New BC600 firmware version 1.15, release 2349 New PARSOFT version 1.34.1 – changes for BC600

The BC600 firmware comprises the operating software of the Fire Detection Control Panels Series BC600, including the function modules.

1.1 New contact type "NC-contact" of loop input modules

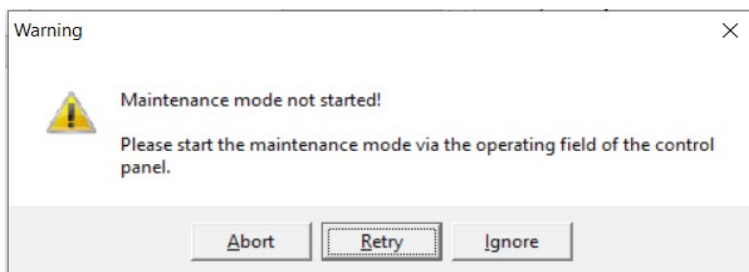
For the following input modules of the detector system "System Sensor", from now on the contact type **NC-contact** can also be selected:

Some position switches only offer a normally closed contact. In this case the new function is advantageous because from now on, no coupling relays or the like for externally converting the contact type from **NC-contact** to **NO-contact** are needed.

2.1 Copying whole loops (LIF(R)601)

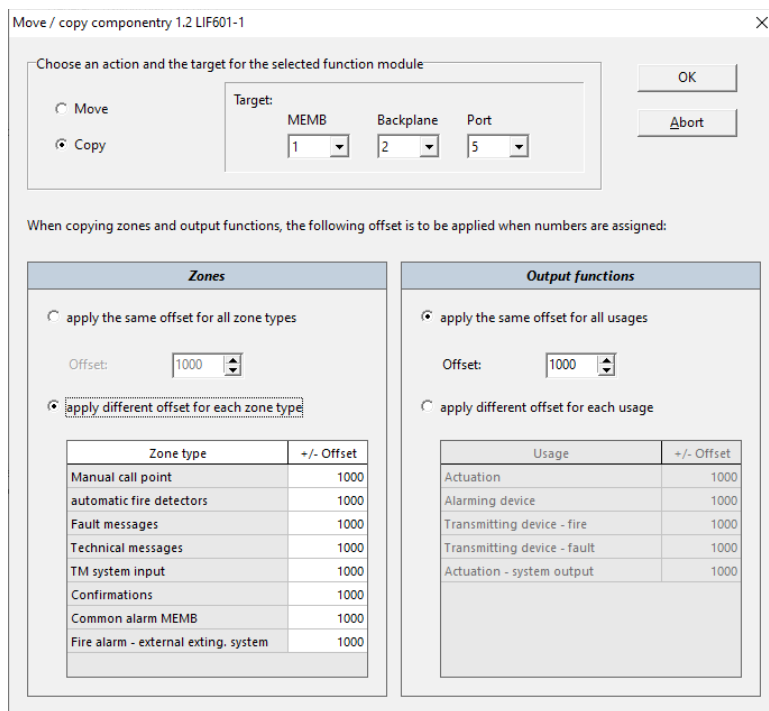
If systems include identical or similar areas (for example, standard floors), each of which is covered by one loop, much time can be saved during the creation of the configuration by copying whole loops.

The process of copying a loop is started in the window **Control panel parameters – System bus** through the context menu **Move / Copy**. Prior to copying, an **offset** must be specified for the parameterised zones and output functions in order to avoid duplicate numbers.

As can be seen in the window shown above, one offset can be jointly set for all zones and one offset can be jointly set for all output functions, or if required, a separate offset can be set for each zone type or output type. In this way, the logic numbers can be optimally managed even in large or very large projects.

2.4 User management

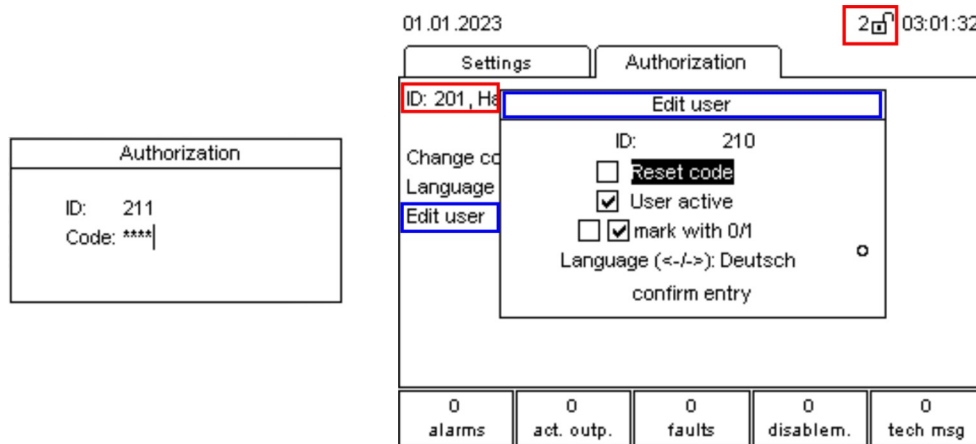
With the new function "User management" you can easily and transparently analyse at any time the operations carried out by the different users – even in case of events that occurred long ago – and you can also set limitations for individual user groups.

With the user management you get, in addition to the assignment of individual rights, also an even more flexible management of the users through other users on the operating field of the BC600. This function also allows, among other things, users to be activated or user codes to be changed in an easy and clear way – even through third parties. This is a big help which always gives you an optimum overview of all users when employees join or leave a firm, or when there are vacation substitutes.

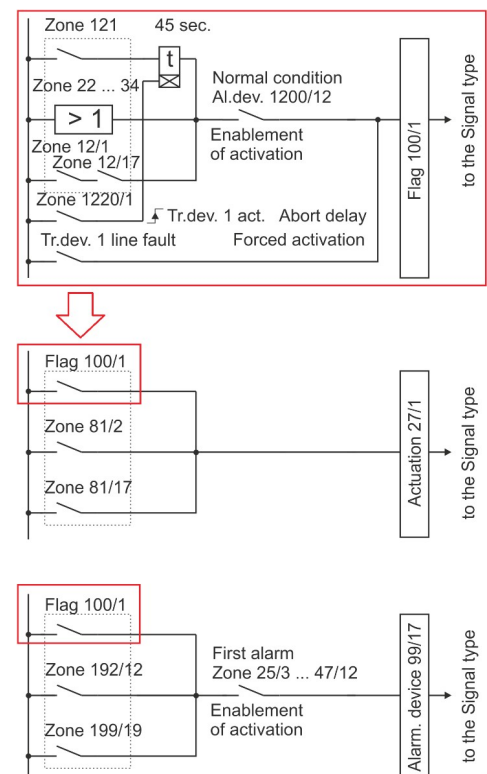
Left image: Login window: The first digit is evaluated as first digit of the user **ID**. The Enter key allows you to change to the second line **Code**, where the code is entered as usual.

Right image: If a user has logged in, the first line in the **Authorization** menu indicates the user ID and the name that has been entered in PARSOFT. Depending on the rights that have been set in PARSOFT, the menu **Edit user** allows you to

- **reset the code** (for users with authorization level 2 to 1111 and for users of authorization level 3 to 99999)
- **activate the user** or deactivate the user
- set the **language** for the user.
